**STAFF REPORT  
KETCHUM PLANNING AND ZONING COMMISSION  
REGULAR MEETING OF December 14, 2021**

**PROJECT:** Grossman Residence – Remodel/Addition

**FILE NUMBER:** P21-89

**APPLICATION TYPE:** Mountain Overlay Design Review

DRAWING NAME:  
 PROPOSED EXTERIOR ELEVATIONS  
 EAST  
 SOUTH  
 NORTH  
 DATE:  
 5.27.21  
 SCALE:  
 1/4" = 1'-0"  
 SHEET NO.  
**A.7**  
 8.25.21

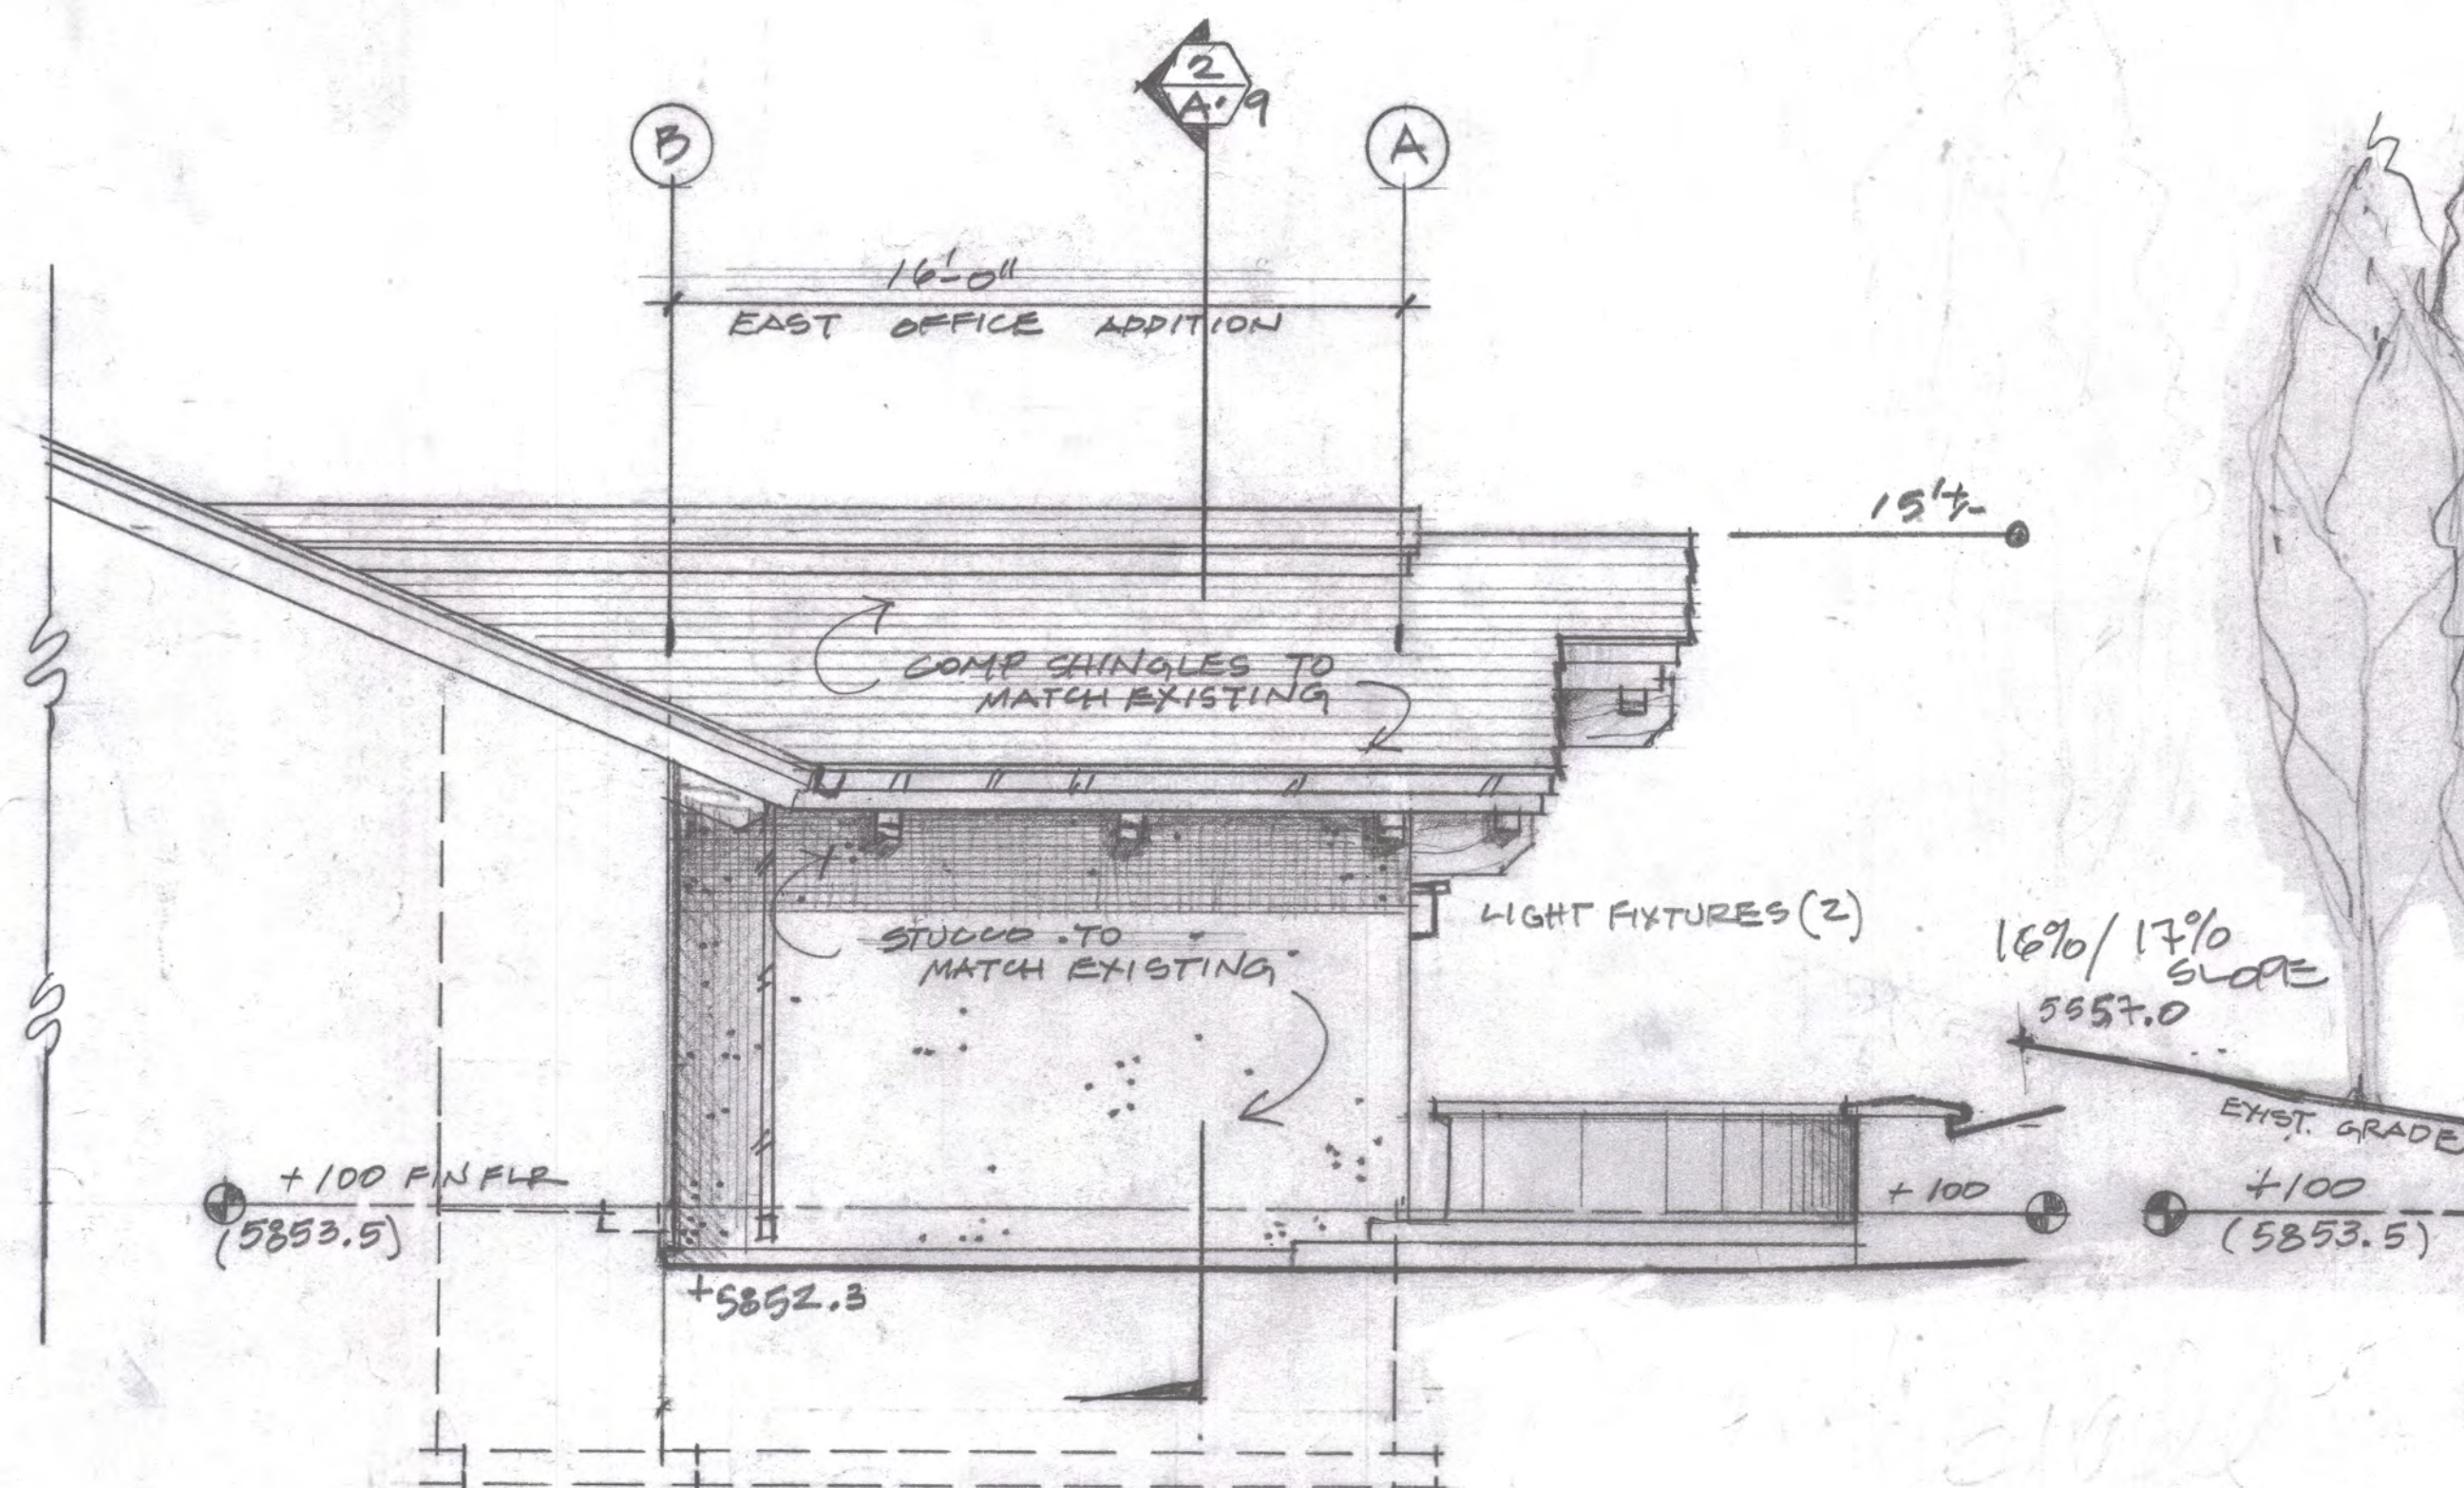
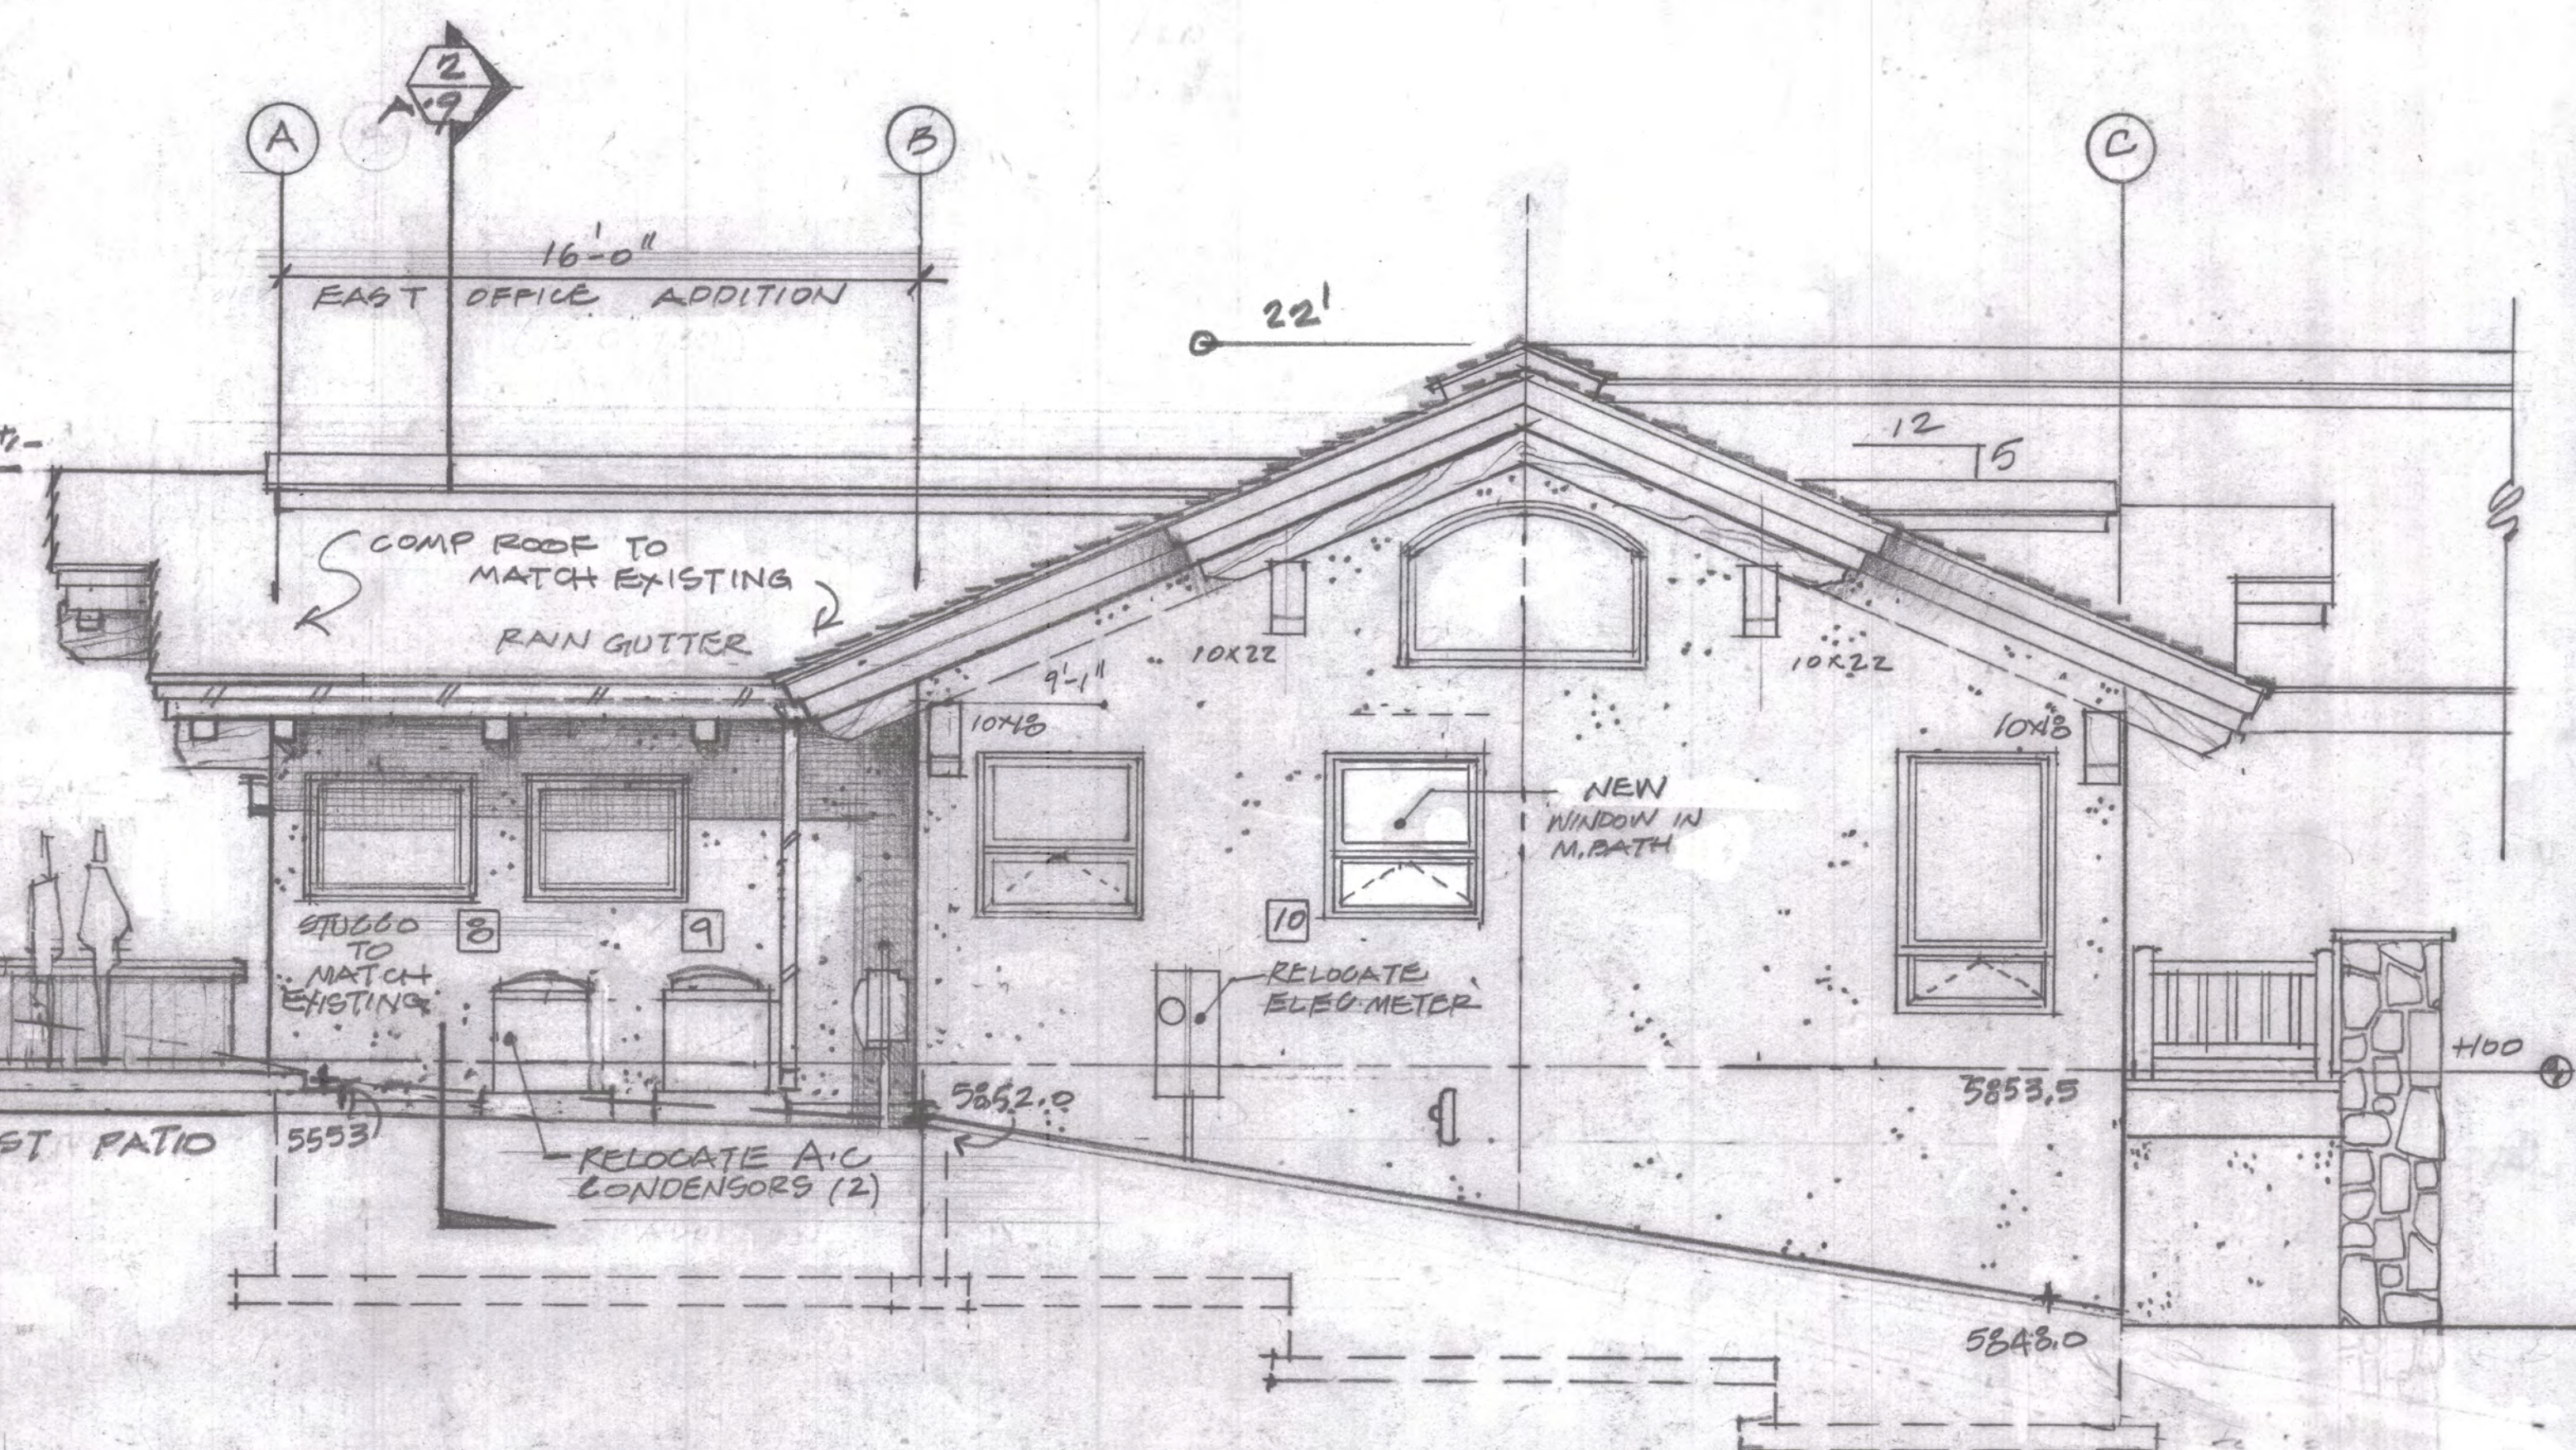
<i>Staff Comments</i>	<i>Building elevations are included on Sheet A.7 of the Design Review submittal. The addition uses the same architectural features as the existing building with the same roof form and materials. The addition uses windows to break up the stucco material. Architectural features of the addition will only be seen by the adjacent property owners as the addition is small in nature and located on the rear of the building.</i>
<input checked="" type="checkbox"/>	<input type="checkbox"/>	<input type="checkbox"/>	17.96.060(F)(3)	<b>There shall be continuity of materials, colors and signing within the project.</b>
			<i>Staff Comments</i>	<i>The proposed materials and color palette match the existing residence. The materials and colors complement the surrounding landscape.</i>
<input checked="" type="checkbox"/>	<input type="checkbox"/>	<input type="checkbox"/>	17.96.060(F)(4)	<b>Accessory structures, fences, walls and landscape features within the project shall match or complement the principal building.</b>
